Technical Service Bulletin

REAR THREE-DIAMOND LOGO PLACEMENT - SERVICE MANUAL REVISION

No: TSB-13-51-001

MODEL: 2013 Outlander Sport/RVR

2013 Outlander Sport RVR Group 51 Exterior > Mark > Removal and Installation

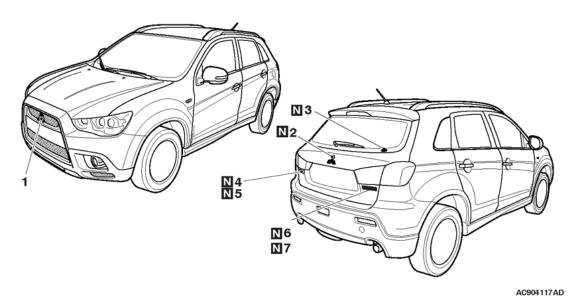
This TSB updates the locating measurement of the three-diamond mark on the liftgate.

Make the following updates to the 2013 Outlander Sport RVR Service Manual: Group 51 Exterior > Mark > Removal and Installation

1. Installation position Attach each mark to the position shown in the illustration.

2. Rear three-diamond mark
